# UNITED STATES PATENT AND TRADEMARK OFFICE

APPLICATION NO.	FILING DATE	FIRST NAMED INVENTOR	ATTORNEY DOCKET NO.	CONFIRMATION NO.
10/050,978	01/18/2002	Robert C. Beck	2445	2176

## Office Action Summary

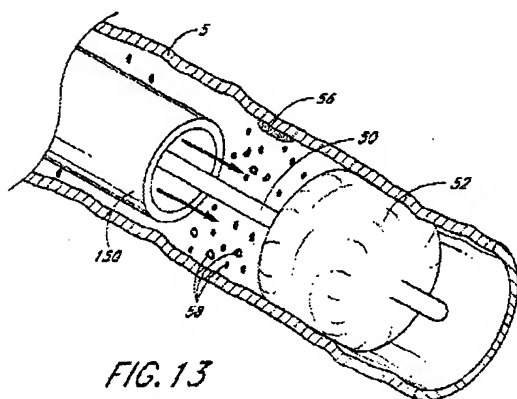
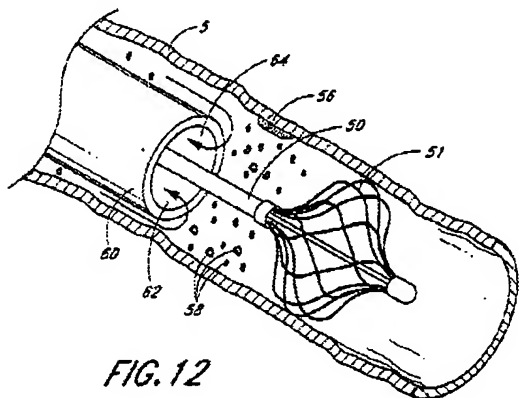
**Claims 1, 11, 12, and 13** are rejected under 35 U.S.C. 102(b) as being anticipated by Muni, et al., U.S. Patent Number 6,454,741.

The cited patent teaches and shows in figures 12 and 13, the steps of inserting and positioning an occlusion device in a vessel without placing an occlusion device proximal of the lesion in the same vessel, treating the lesion, positioning an extraction section at a location near the lesion, supplying a fluid to the extraction section, and providing a sheath having an extraction lumen proximal of the extraction section.

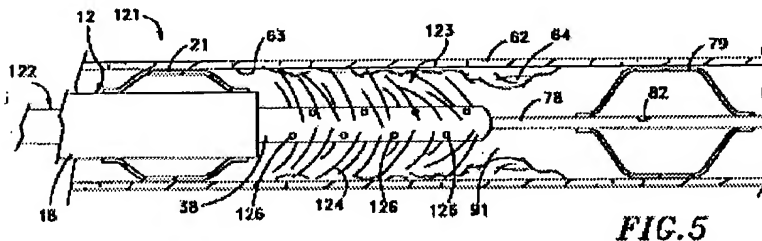
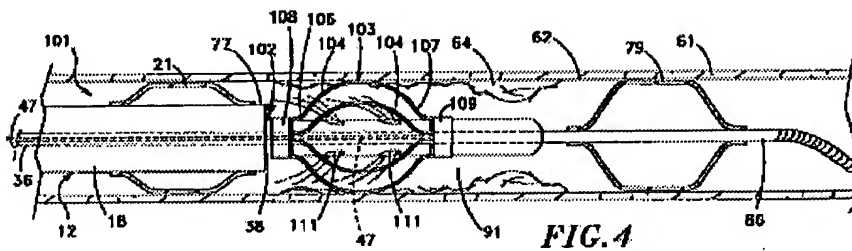
As referenced above, Muni shows in figures 12 and 13, the steps of inserting and positioning a single balloon occlusion device in a vessel without placing an occlusion device proximal of the lesion in the same vessel, treating the lesion, positioning an extraction section at a location near the lesion, supplying a fluid to the extraction section, and providing a sheath having an extraction lumen proximal of the extraction section. Imran teaches the use of triple balloon devices to treat affected areas in vessels.

Figures 4 and 5 of the Imran Patent show various embodiments use for the treatment of stenosis in vessels. Please note that figure 4 shows an embodiment with three balloons and figure 5 shows an embodiment with two balloons and bristles (124).
